HOPE CREEK GENERATING STATION
DOCKET NO. 50-354
DRAFT SAFETY EVALUATION REPORT
FSAR QUESTION 421.10

Pursuant to discussions with the Power Systems Branch,
attached is a copy of revised FSAR Question 421.10 previ-
ously transmitted on September 7, 1984.

QUESTION 421.10 (SECTION 7.1 & 7.2)

Electrical Protection Assemblies (EPAs) in
The Power Range Neutron Monitoring System

FIGURE 7.6-11

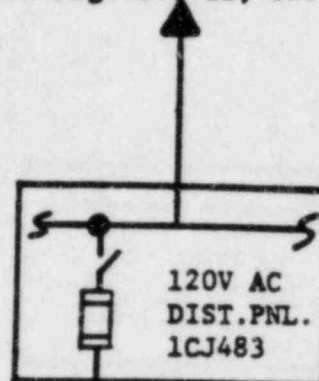
Electrical protection assemblies have been added between the power range NMS panel (10C608) and its two 120V ac UPS power feeders as described in revised Section 7.6.1.4.2.

Electrical protection assemblies (EPAs) identical to those used in the reactor protection system (RPS) (described in Section 8.3.1.5.4) are installed between the power range NMS and the two 120V AC feeders from the UPS power sources (see Figure 7.6-11). The EPAs ensure that the power range NMS never operates under degraded bus voltage or frequency conditions (undervoltage, overvoltage, underfrequency). The power range NMS panel (10C608) was analyzed with this power supply configuration to ensure that no single failure of the power range NMS could inhibit the proper operation of the reactor protection, ~~system or any other safety system~~, required for the safe operation of the plant. The interfaces between the power range NMS and the RPS have adequate provisions for separation. The RPS cabling external to the NMS panel conforms to the separation guidelines of Regulatory Guide 1.75, which the RPS must satisfy. Within the panel, where the cable and wiring runs to the different RPS divisions do not conform to the Regulatory Guide 1.75 separation criteria, fire-resistant "Sil-Temp" tape is wrapped around the cables and wires. This eliminates the possibility of fault propagation between the RPS divisions. In accordance with paragraph 5.6.2 of IEEE Standard 384, this tape has been demonstrated to be acceptable. Separation criteria for the rod block monitor, recirculation flow control, reactor manual control, and the redundant reactivity control systems has not been changed.

FIGURE 1 - APRM Panel Assignment

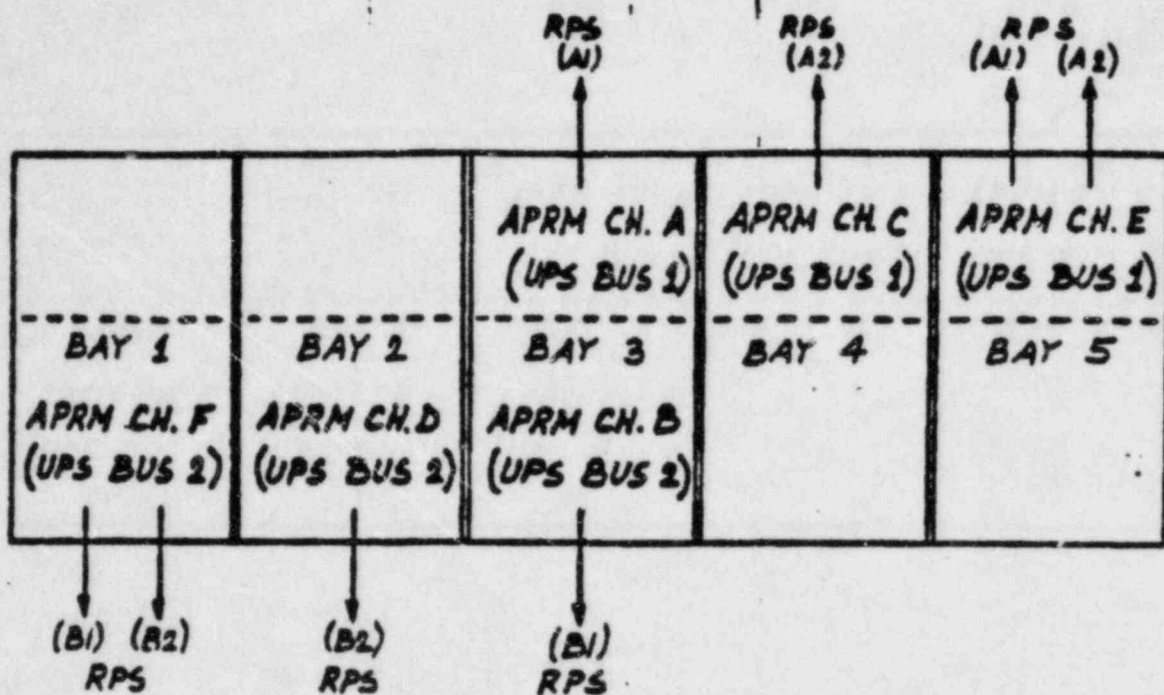
Figures 1 and 2 depict schematically the physical arrangement of the equipment in NMS and PRMS panels H11-P608, H11-P635, and H11-P636. The designs of these panels are similar to those of NMS and PRMS panels used in several BWR plants accepted by the NRC.

Adequate separation in the NMS and PRMS panels is achieved by using the bay design depicted in Figures 1 and 2, by using relay coil-to-contact as sufficient separation/isolation, and by separation between divisions/channels/wiring. Where conformation with Regulatory Guide 1.75 separation criteria cannot be achieved, the best-effort design is used.

FIGURE 2 - Radiation Monitoring Panels

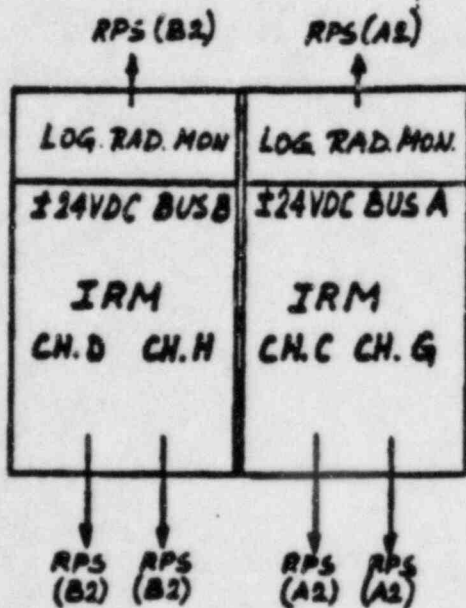
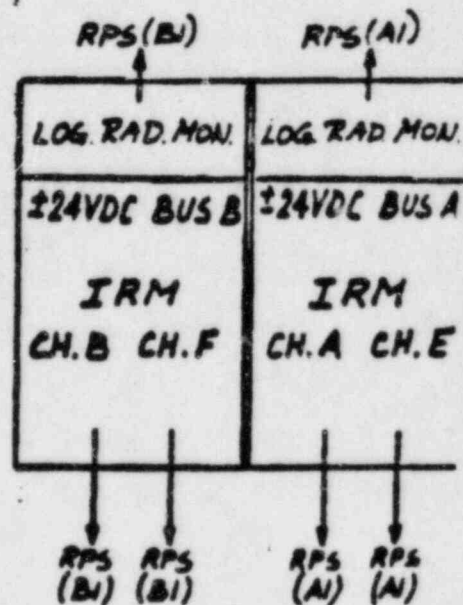
As shown in Figures 2 and 7, if one bay of panels H11-P635 or H11-P636 were to fail in an untripped condition, the remaining bays would be capable of sending sufficient RPS signals even if one of the IRM channels were bypassed. The IRM bypass switches can bypass one IRM channel at a time.

FIGURE 3 - APRM/RPS Signal Separation

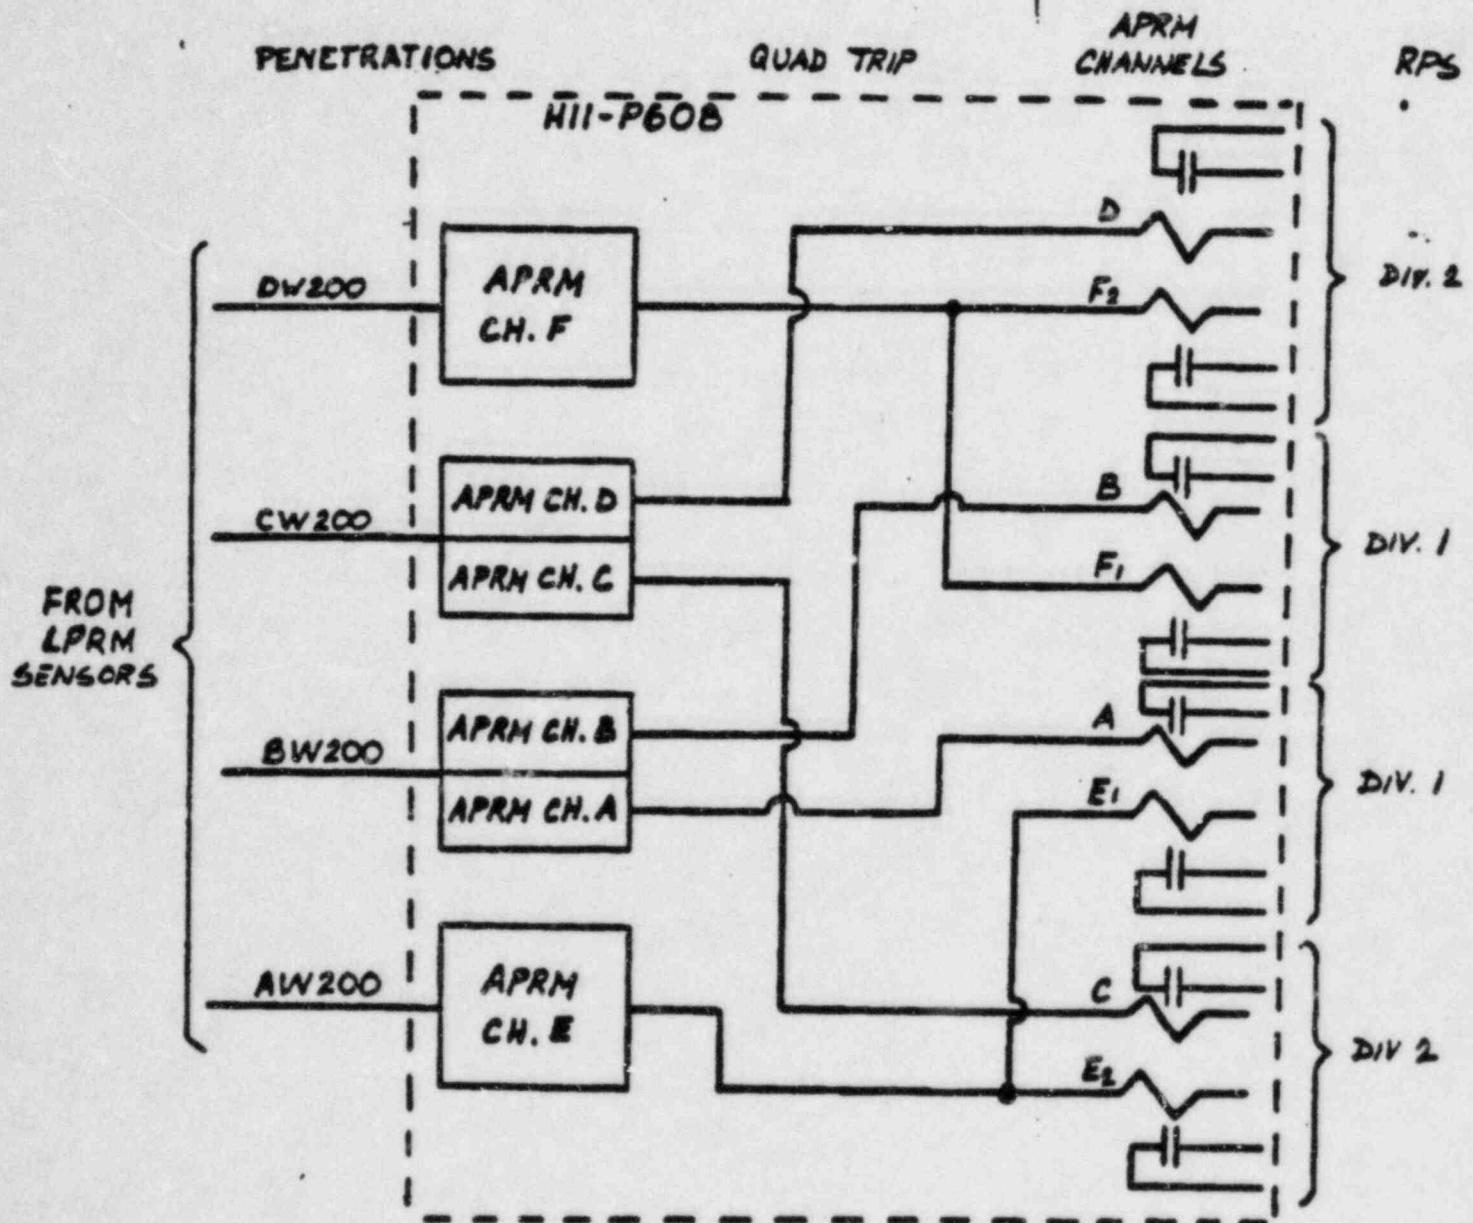
As shown in Figure 3, the isolation/separation precludes the propagation from outside the NMS cabinets ^{of} failures that could cause the loss of any safety function.
